# AP1000 TECHNICAL REPORT REVIEW

## Response to Request For Additional Information (RAI)

RAI Response Number: RAI-SRP9.1.2-SEB1-02  
Revision: 2A

RAI Response Number: RAI-TR44-009  
Revision: 2A

Figure 9.1-1 (Sheet 1 of 2)  
New Fuel Storage Rack Layout (72 Storage Locations)

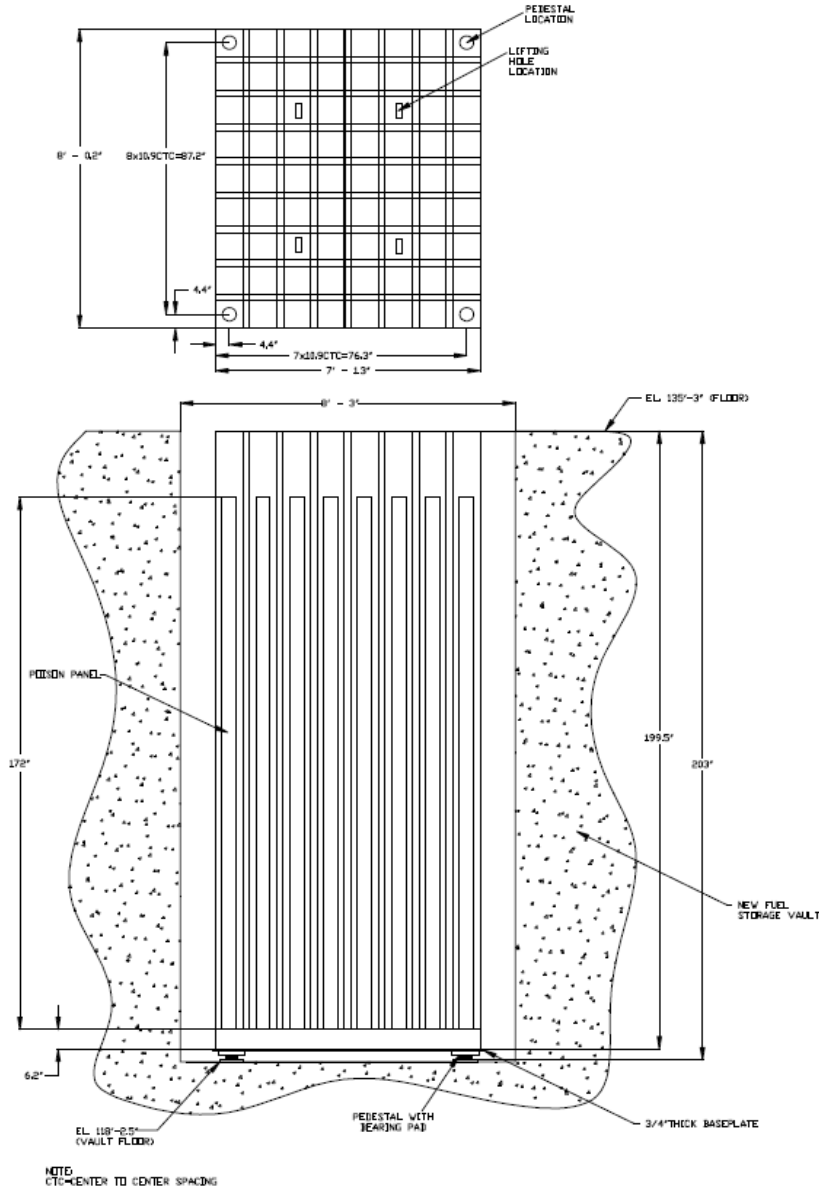
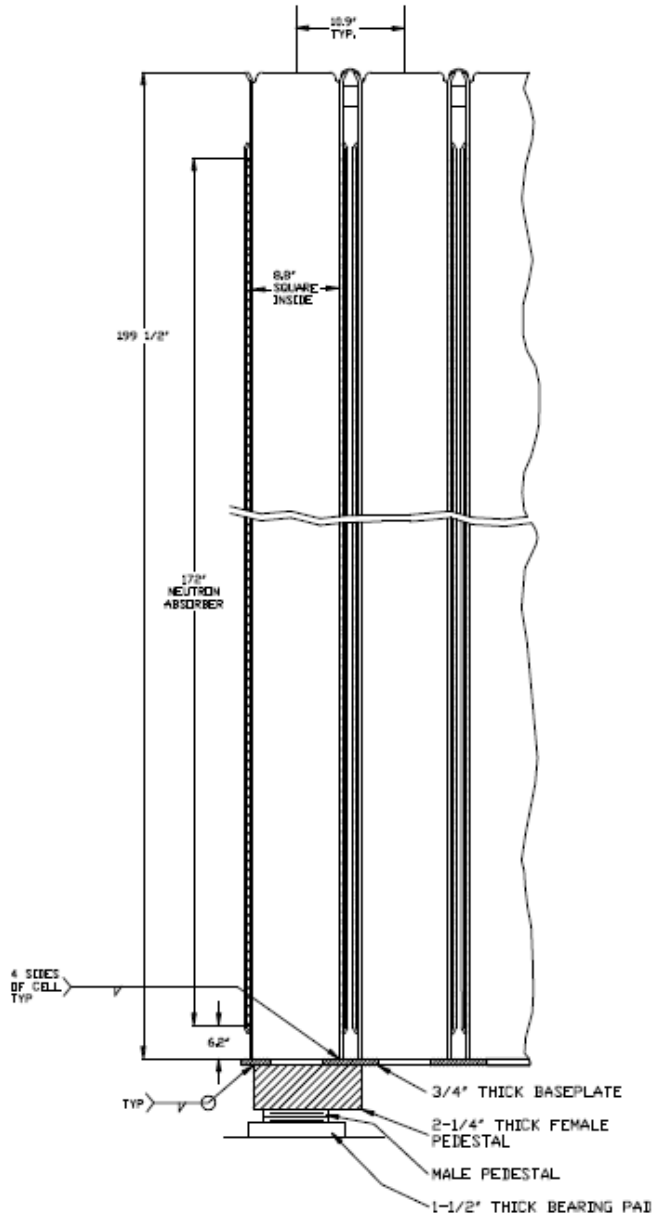
In the markup of the DCD, provided in Section 5 of the topical report, Figure 9.1-1, New Fuel Storage Rack, is identified for deletion. Please explain why you are deleting this figure. This figure should be retained in the DCD.

During the June 2010 audit, the NRC requested that dimension and gap information for the new fuel racks be clarified between the three similar RAIs (RAI-TR44-09, RAI-TR44-017, RAI-TR44-25) to show consistency and alignment to the current design basis shown in DCD Figure 9.1-1.

Figures 9.1-1 (Sheet 1 of 2) and Figures 9.1-1 (Sheet 2 of 2) are changed as shown below.

The change provided in the Revision 1 DCD Markup Section to Sheet 1 of Figure 9.1-1 is outdated. The most recent change to this DCD figure is included in the Revision 3 response to RAI-TR44-17. The change provided in the Revision 1 DCD Markup Section of this RAI to Sheet 2 of Figure 9.1-1 is still applicable.
